NLS2015073
August 6, 2015

Subject: License Amendment Request to Revise Technical Specifications to Relocate
Pressure and Temperature Limit Curves to a Pressure and Temperature Limits
Report
Cooper Nuclear Station, Docket No. 50-298, License No. DPR-46

**Proposed Technical Specification Revision
(Markup)**

Figure 3.4.9-1
Pressure/Temperature Limits for
Non-Nuclear Heatup or Cooldown Following Nuclear Shutdown
Valid Through 32 EFY

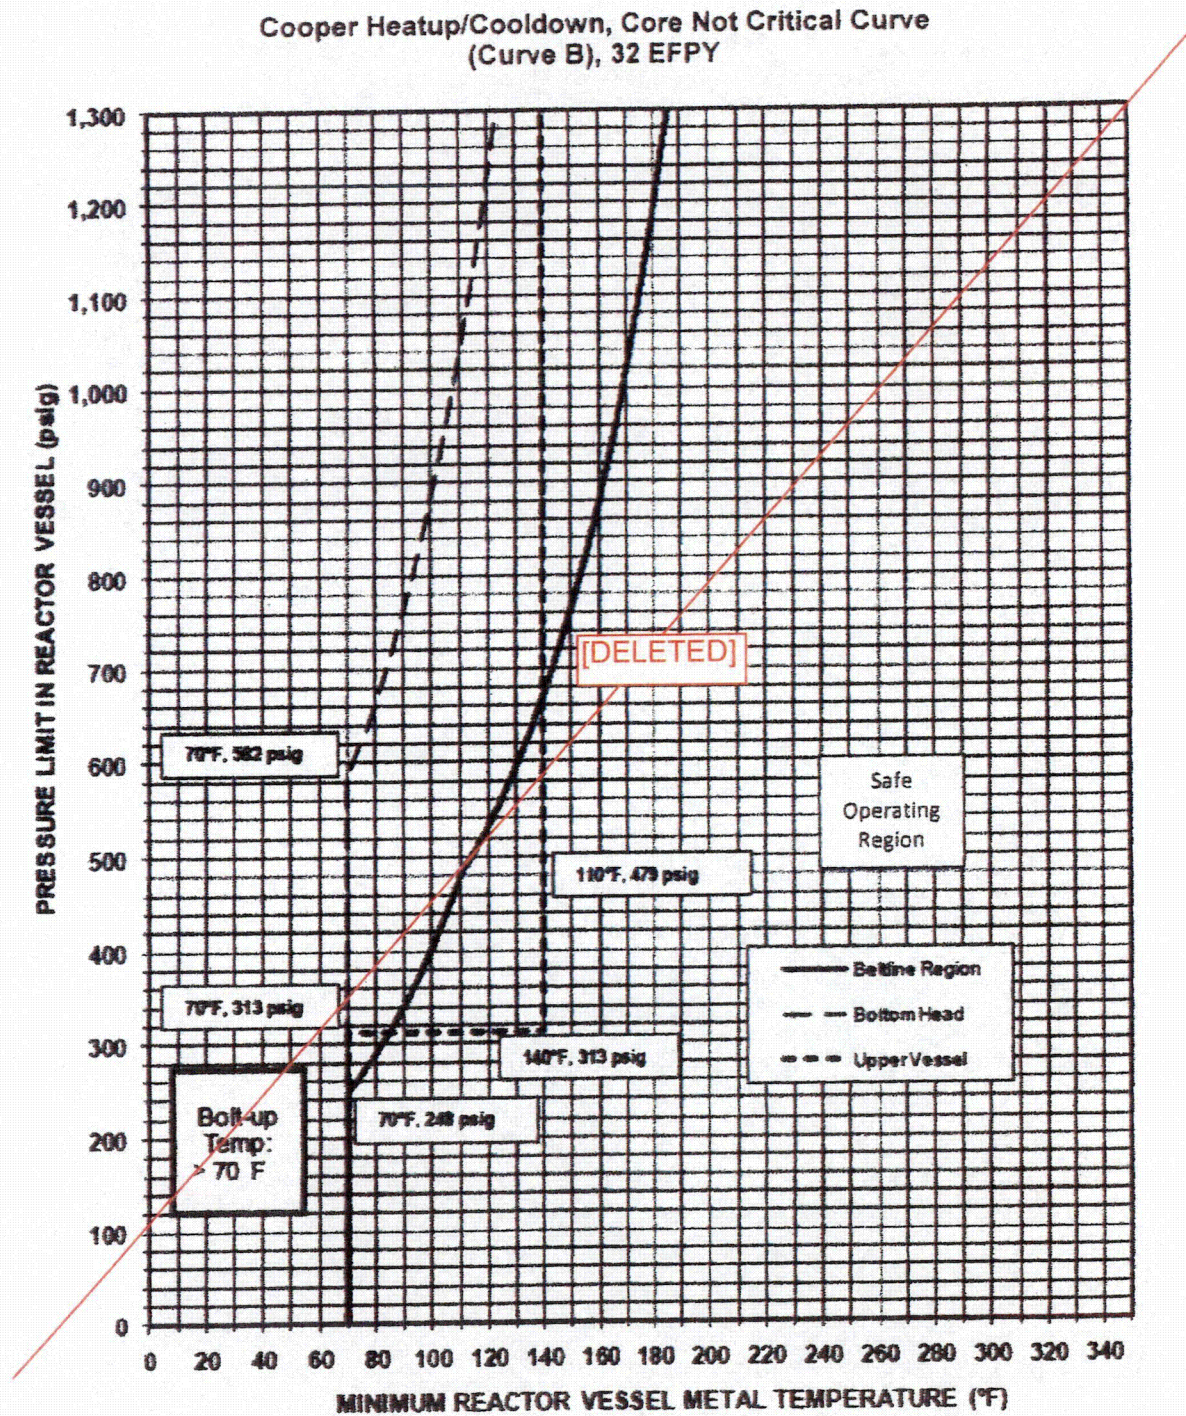
2. TS Section 3.4.9, "RCS Pressure and Temperature (P/T) Limits" - The current specified heatup and cooldown rates, temperature limits, and associated figures are replaced with a reference to the PTLR.

RCS pressure and temperature (Beltline, Bottom Head, and Upper Vessel) are within the applicable limits of Figure 3.4.9-1 and Figure 3.4.9-2, and heatup or cooldown rates are $\leq 100^\circ\text{F}$ when averaged over a one hour period during RCS heatup, cooldown, and inservice leak and hydrostatic testing (The Adjusted Reference Temperature (ART) beltline region must be determined from Figure 3.4.9-2. During RCS heatup and cooldown operation (i.e., not critical and not performing inservice leak or hydrostatic testing) verify RCS pressure and temperature are within the applicable limits specified in Figure 3.4.9-1. During RCS inservice leak and hydrostatic testing verify RCS pressure and temperature are within the applicable limits specified in Figure 3.4.9-2;

LCO 3.4.9 RCS pressure, RCS temperature, RCS heatup and cooldown rates, and the recirculation pump starting temperature requirements shall be maintained within the limits.

specified in the PTLR

Figure 3.4.9-3
Pressure/Temperature Limits for Criticality
Valid Through 32 EFY

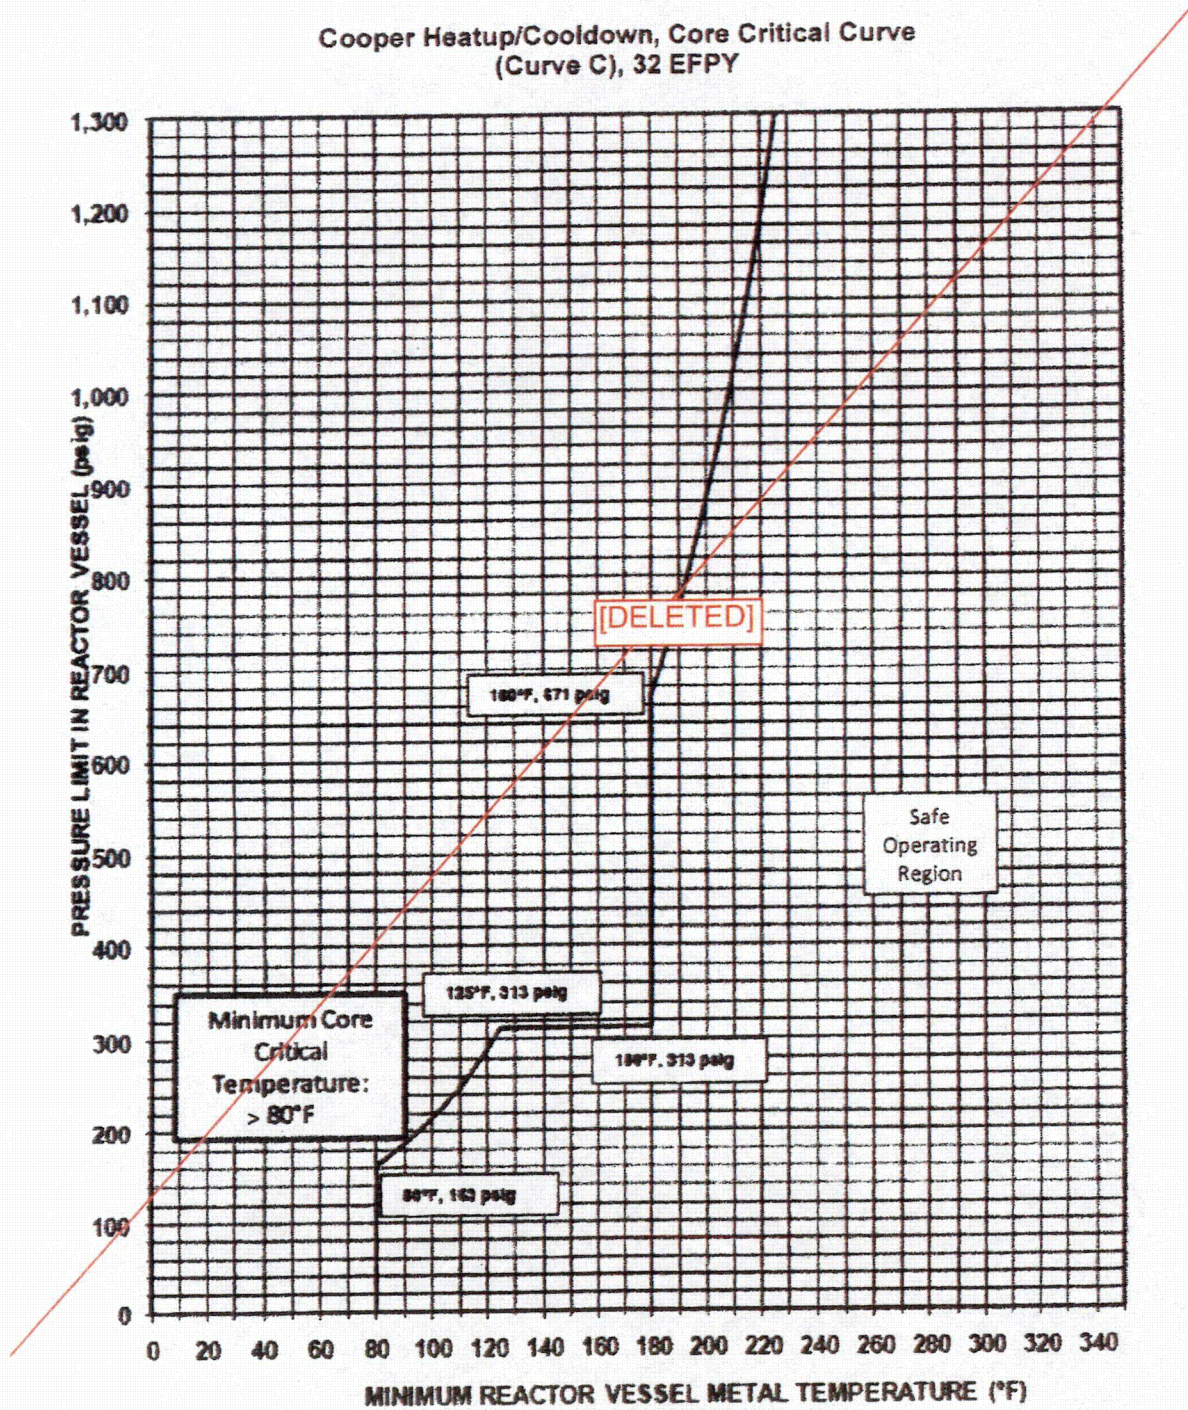
SURVEILLANCE	FREQUENCY
<p>SR 3.4.9.2 Verify RCS pressure and RCS temperature are within the criticality limits specified in Figure 3.4.9-3.</p> <p style="text-align: center;">the PTLR.</p>	<p>Once within 15 minutes prior to control rod withdrawal for the purpose of achieving criticality</p>
<p>SR 3.4.9.3 -----NOTE----- Only required to be met in MODES 1, 2, 3, and 4 during recirculation pump startup.</p> <p>Verify the difference between the bottom head coolant temperature and the reactor pressure vessel (RPV) coolant temperature is ≤ 145°F.</p> <p style="text-align: center;">within the limits specified in the PTLR.</p>	<p>Once within 15 minutes prior to each startup of a recirculation pump</p>
<p>SR 3.4.9.4 -----NOTE----- Only required to be met in MODES 1, 2, 3, and 4 during recirculation pump startup.</p> <p>Verify the difference between the reactor coolant temperature in the recirculation loop to be started and the RPV coolant temperature is ≤ 50°F.</p> <p style="text-align: center;">within the limits specified in the PTLR.</p>	<p>Once within 15 minutes prior to each startup of a recirculation pump</p>

d. RCS pressure and temperature are within the criticality limits specified in Figure 3.4.9-3, prior to achieving criticality; and

SURVEILLANCE		FREQUENCY
SR 3.4.9.2	Verify RCS pressure and RCS temperature are within the criticality limits specified in the PTLR.	Once within 15 minutes prior to control rod withdrawal for the purpose of achieving criticality
SR 3.4.9.3	<p>-----NOTE----- Only required to be met in MODES 1, 2, 3, and 4 during recirculation pump startup.</p> <p>Verify the difference between the bottom head coolant temperature and the reactor pressure vessel (RPV) coolant temperature is within the limits specified in the PTLR.</p>	Once within 15 minutes prior to each startup of a recirculation pump
SR 3.4.9.4	<p>-----NOTE----- Only required to be met in MODES 1, 2, 3, and 4 during recirculation pump startup.</p> <p>Verify the difference between the reactor coolant temperature in the recirculation loop to be started and the RPV coolant temperature is within the limits specified in the PTLR.</p>	Once within 15 minutes prior to each startup of a recirculation pump
